650 NORTH SAN PEDRO ROAD AMENDED FINAL EIR

STATE CLEARINGHOUSE NUMBER: 2004062004

County of Marin | October 22, 2010

FIGURE 3-5
LOT PLAN - REVISED

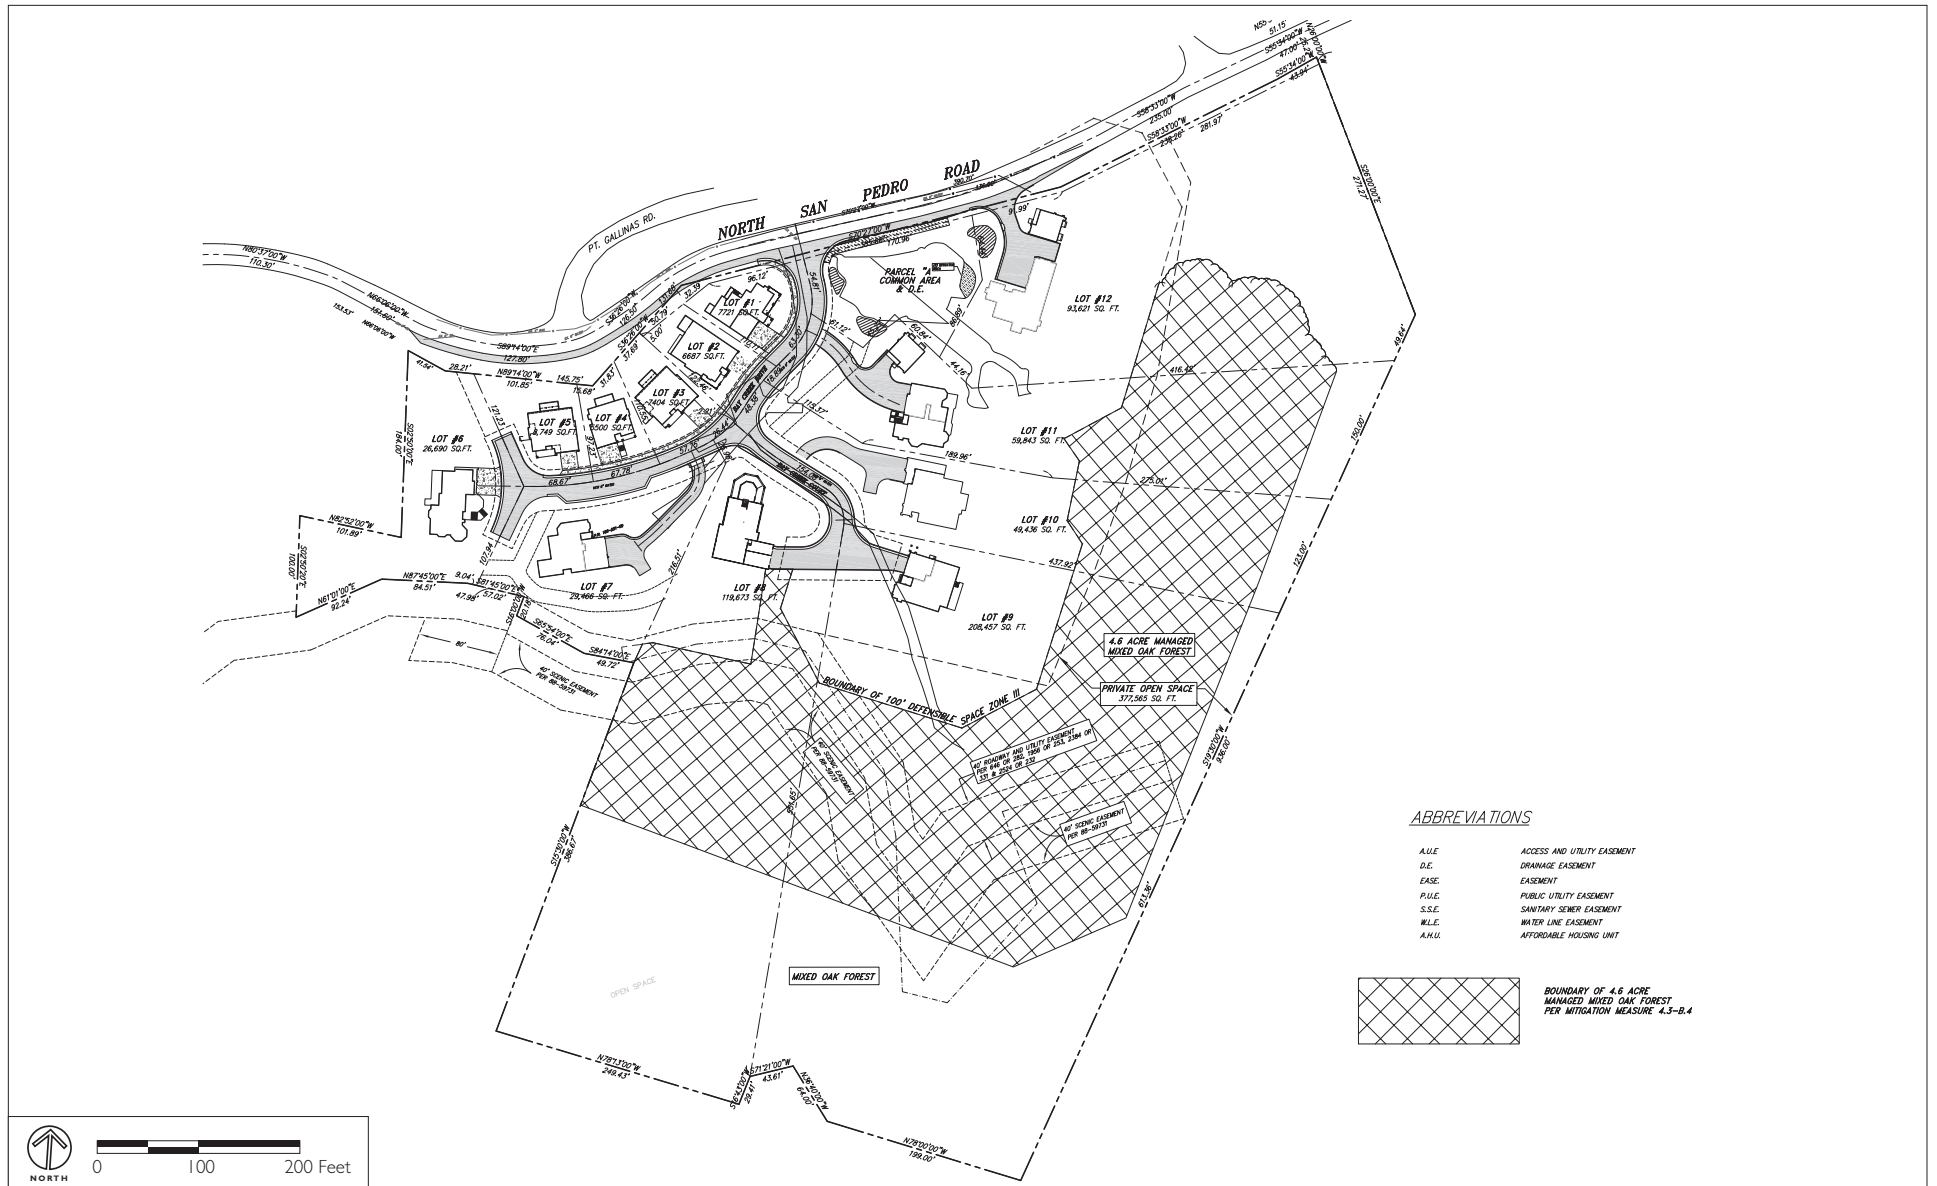
Concerns regarding the location and adequacy of the designated open space area were expressed at the Public Hearing. Figure 3-5 of the DEIR has been updated to show the location of the designated open space within the project site in relation to Defensible Space Zones. Defensible Space Zones are the landscaped and natural areas around each structure that would be designed and maintained to reduce fire danger. Mitigation Measure 4.3-E.2 states that at least 4.5 acres of mixed oak forest within the 8.6 acres of the open space on the site will be maintained as defensible space.

As discussed below, the Fire Hazard and Open Space Management Plan (included in Appendix H) shows the open space within the project site in relation to defensible space.

Concerns were raised at the Public Hearing regarding the defensible areas surroundings proposed residential structures, and how the defensible areas are different than the designated open space area. Additionally, concerns regarding the spread of French broom resulting from the clearing of vegetation within the project site were also expressed. Below is language included as part of the Fire Hazard and Open Space Management Plan (included in Appendix H of this document) to define defensible areas surrounding the proposed residential structures. This language is included to provide a distinction between managed Defensible Space Zones and designated open space.

As shown on the Fire Hazard and Open Space Management Plan, the boundary of the 4.5-acre managed open space (as per Mitigation Measure 4.3-B.4) is

TREE MITIGATION PLAN

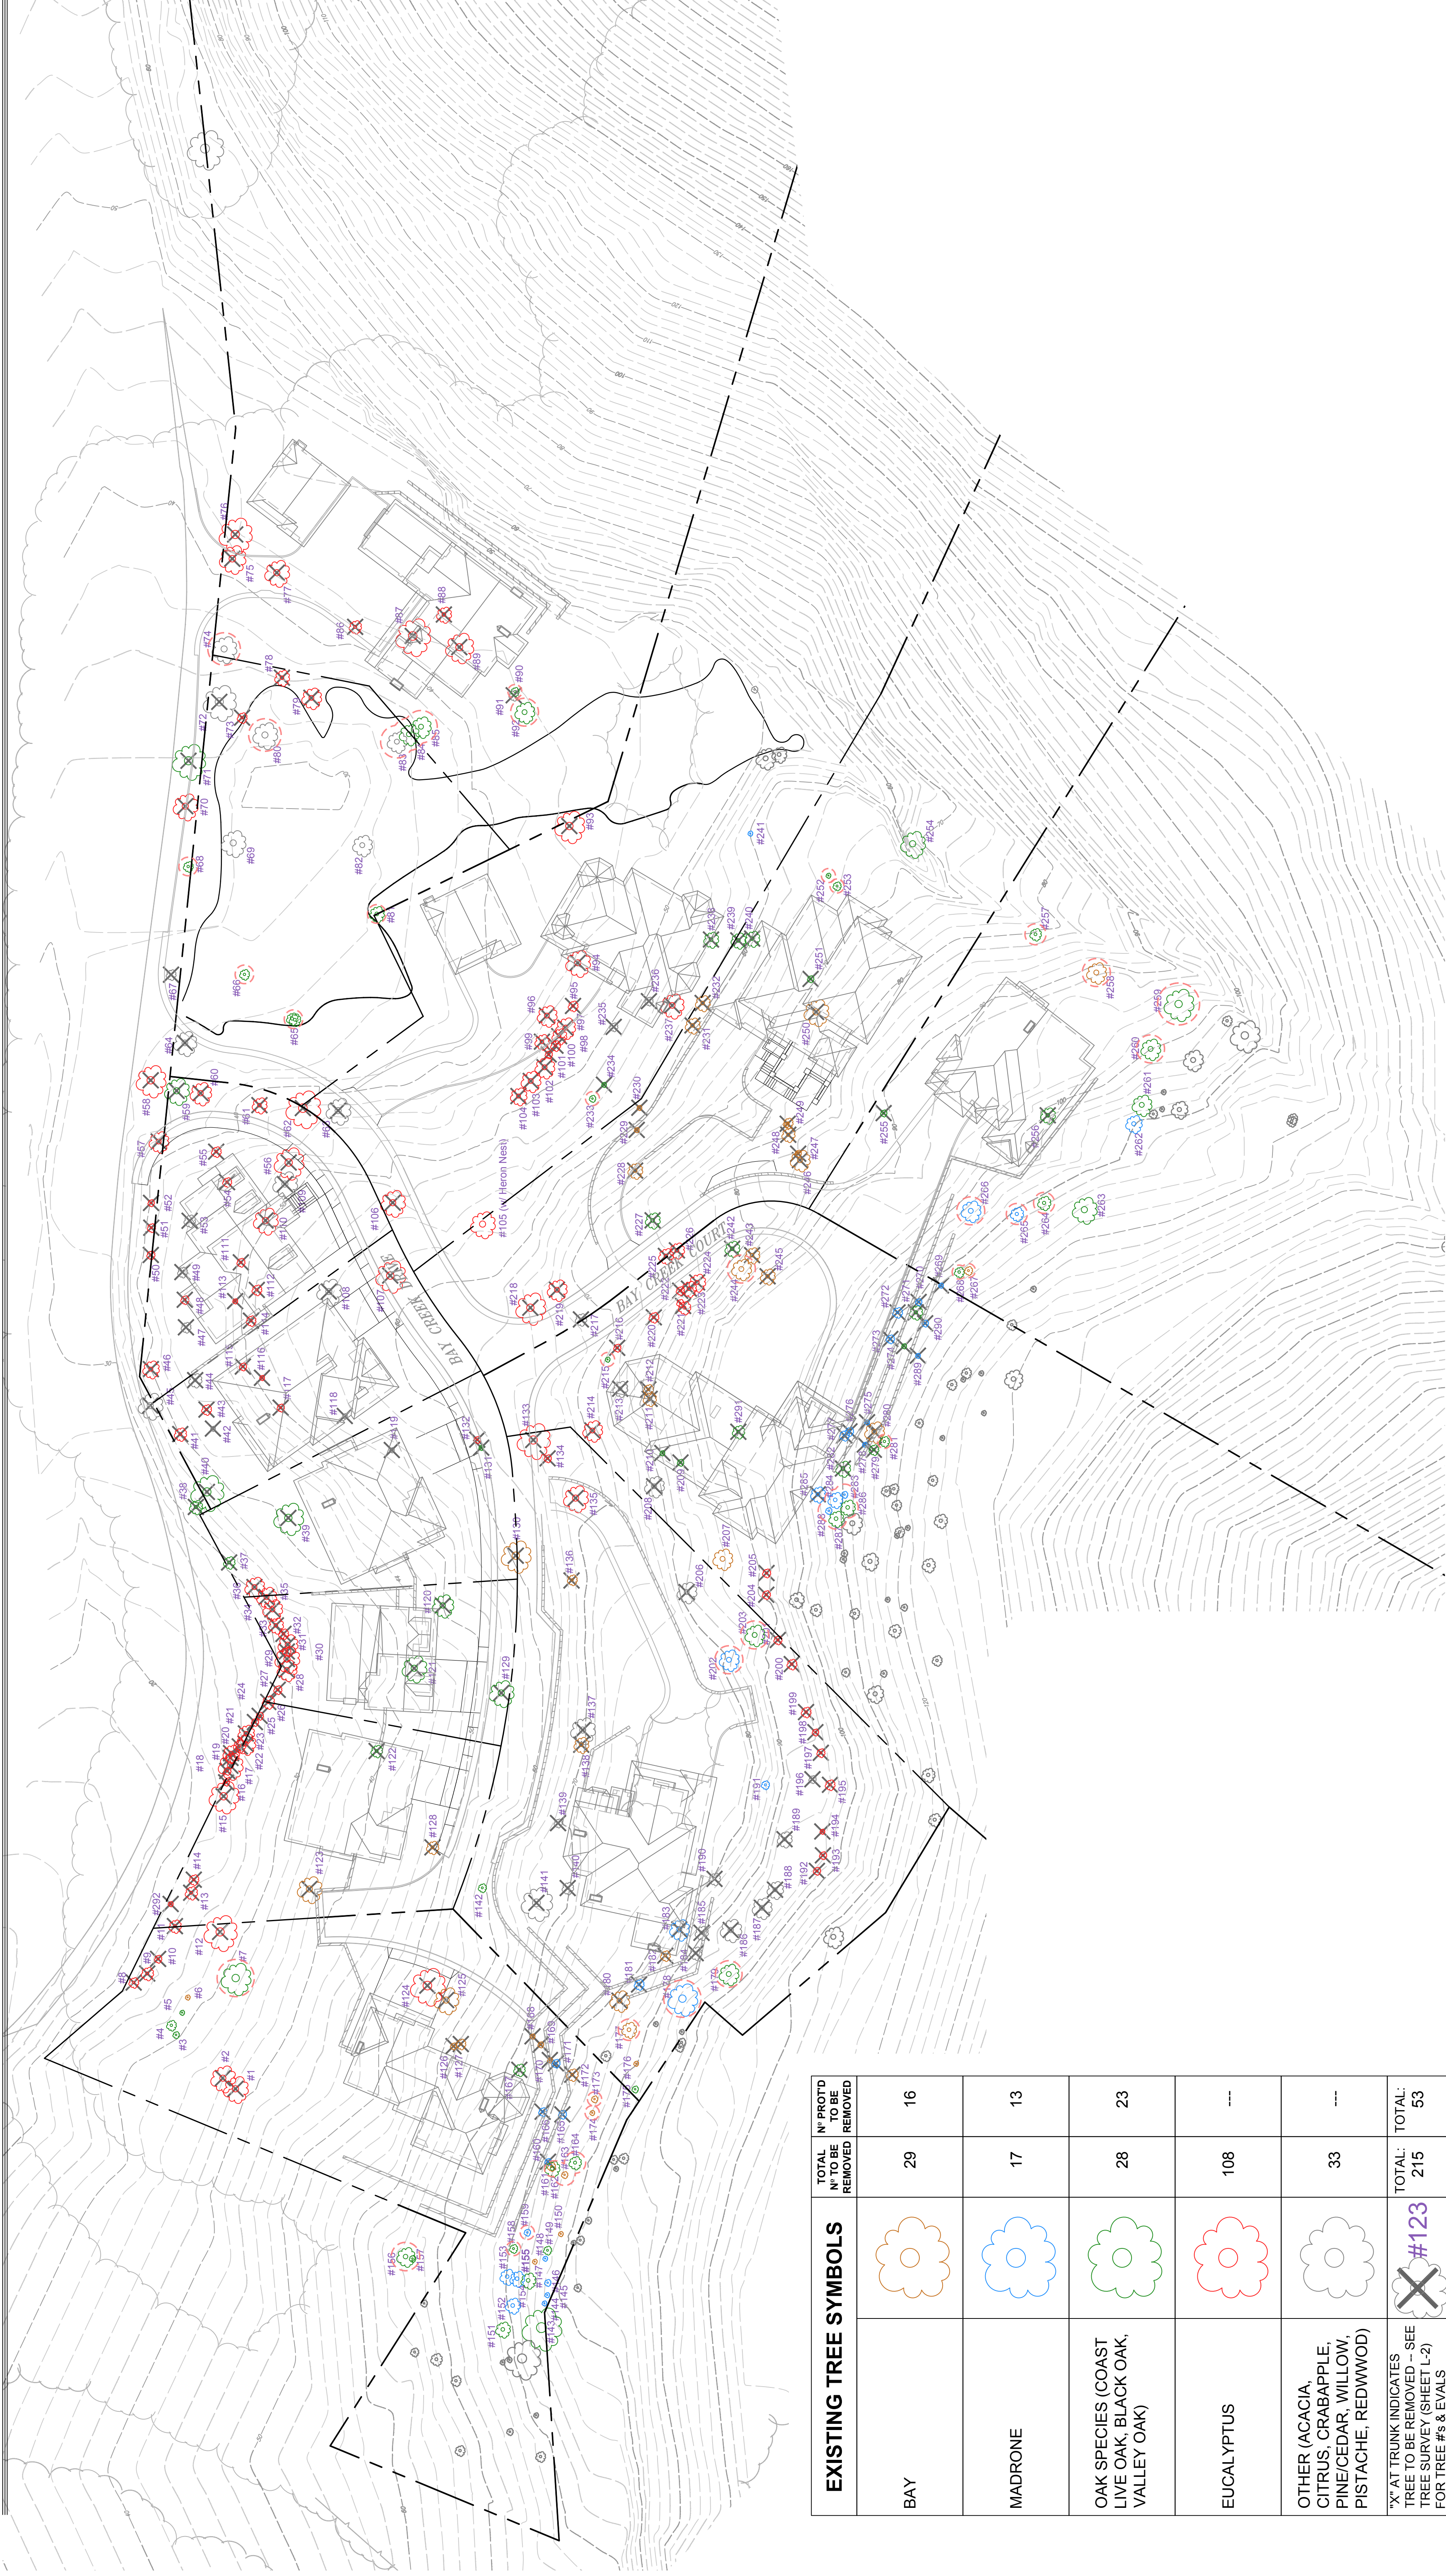
8. Revision required for the Tree Mitigation Plan to address discrepancy in tree heights.

The Tree Mitigation Plan has been revised to match the tree descriptions in the Proposed Mitigation Tree Container Sizes table. The updated Tree Mitigation Plan is included in Appendix E.

FIGURE 1
SITE PLAN SHOWING RECONFIGURED LOT 1

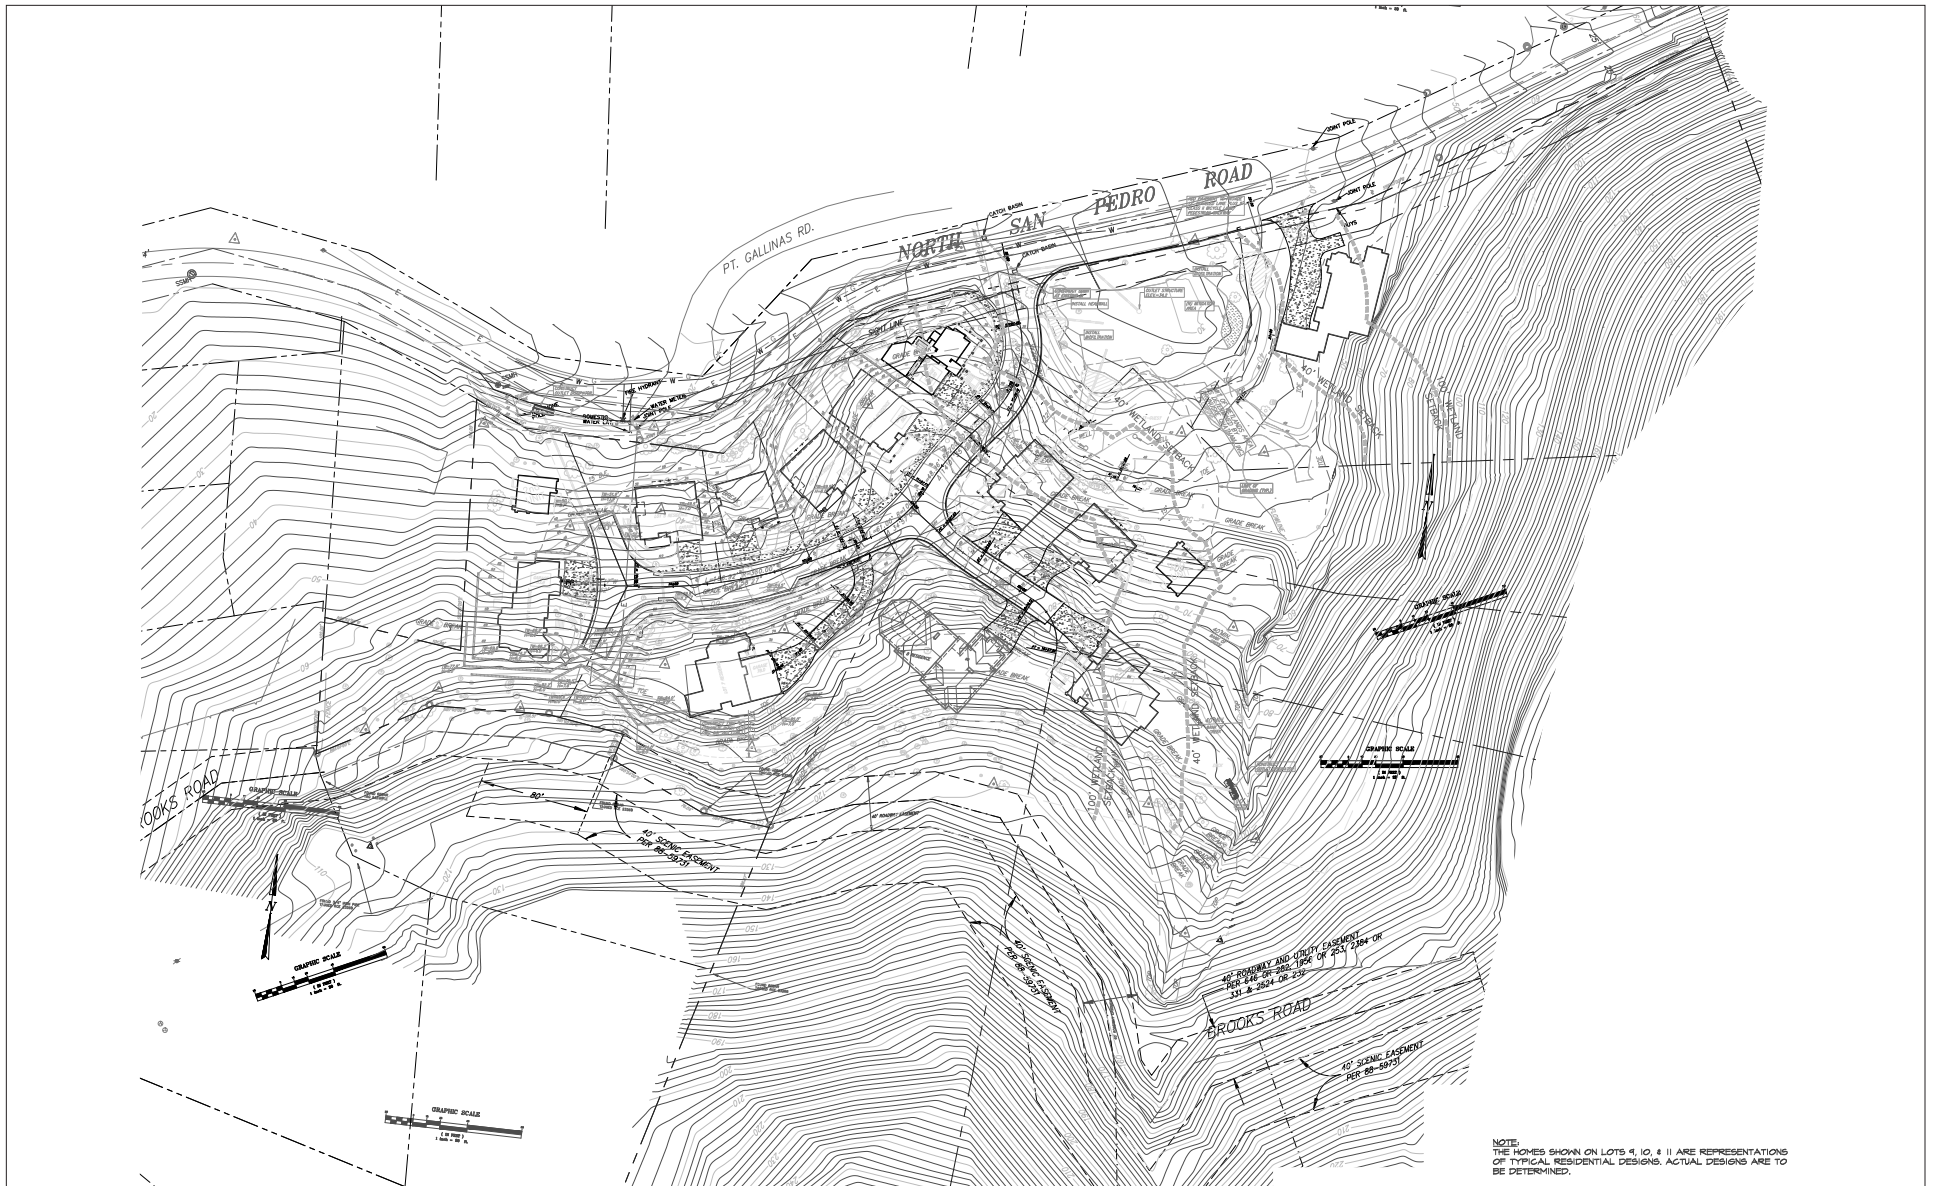
Appendix L, Sight Distance and Lot 1, has been added to the Final EIR to provide additional information. In Appendix L, Figure 1 shows the project site plan with Mitigation Measure 4.6-E.1 pertaining to sight distance incorporated into Lot 1. The footprint for the proposed residence has been relocated to allow for grading and adequate sight distance. Figures 2 shows the sight line from Bay Creek in a westerly direction and Figure 3 shows the sight line profiles from Bay Creek Drive, in a westerly direction. The profiles show sight distance resulting from recontouring the hillside on Lot 1. The diagrams validate the assertion in Mitigation Measure 4.6-E.1 that site distance would be possible subsequent to recontouring of the hillside on Lot 1. Additionally, new photo simulations were created to show what Lot 1 would look like from North San Pedro Road. The photo simulations are now included in the Final EIR as Figures 5-6, 5-7a and 5-7b, and are discussed in this amendment in Section C.2.

- 4.6-E.1 ~~Project Lot 1 should be redesigned to allow the rear yard fence of Project Lot 1 shall~~should to be relocated to approximately 10 feet south of the location currently shown on the Grading and Drainage Plan. ~~If necessary, the footprint of the proposed residence on Lot 1 should also be redesigned.~~

FIGURE 5
PHOTO TO EAST FROM LOT 12 DRIVEWAY

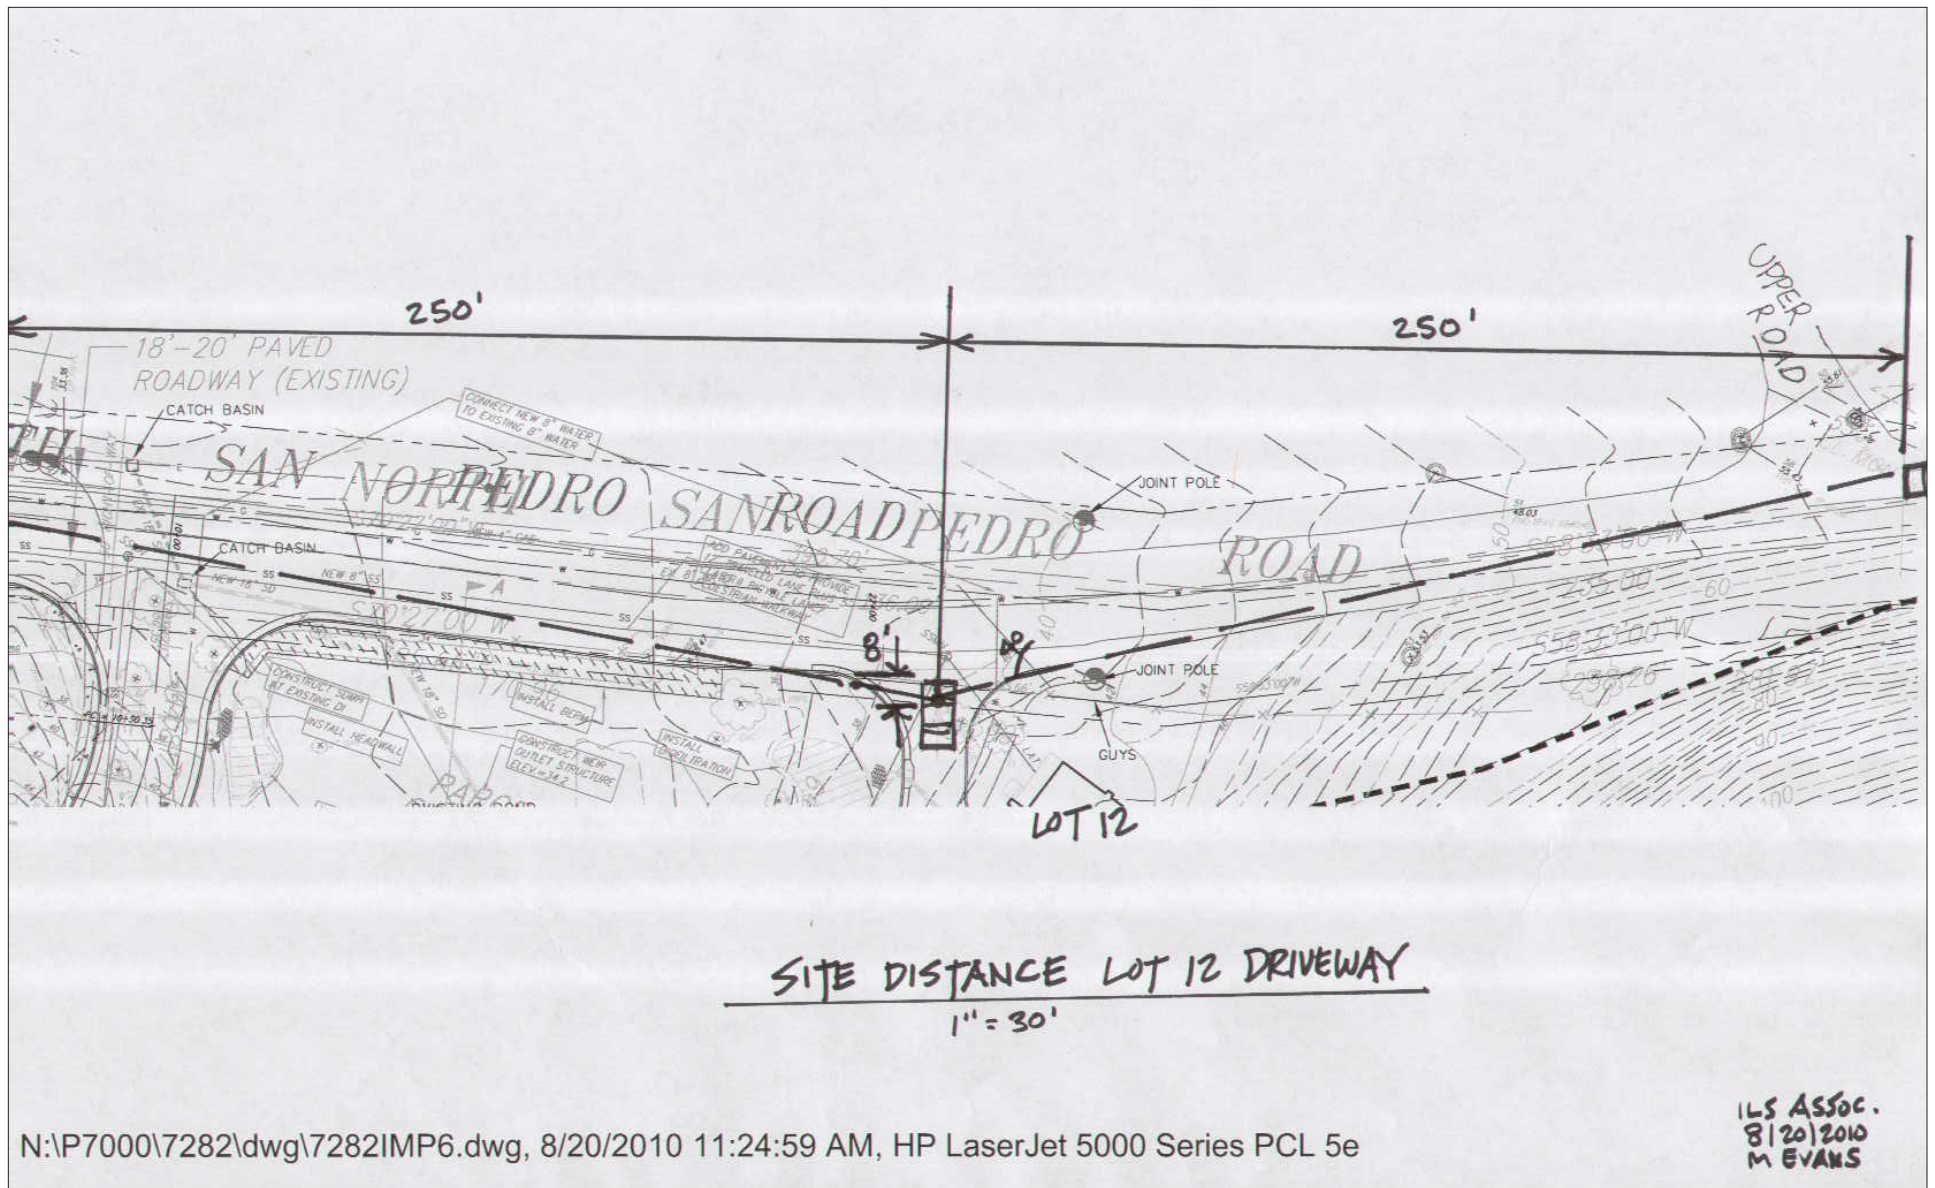
Figures 4 and 5 in Appendix L, show photos of markers demonstrating a direct line of sight 250 feet in each direction from the exit point of the driveway to Lot 12. Figure 6 shows the sight distance line from the Lot 12 driveway. Figures 7 and 8 show sight line profiles from Lot 12. Additional language,
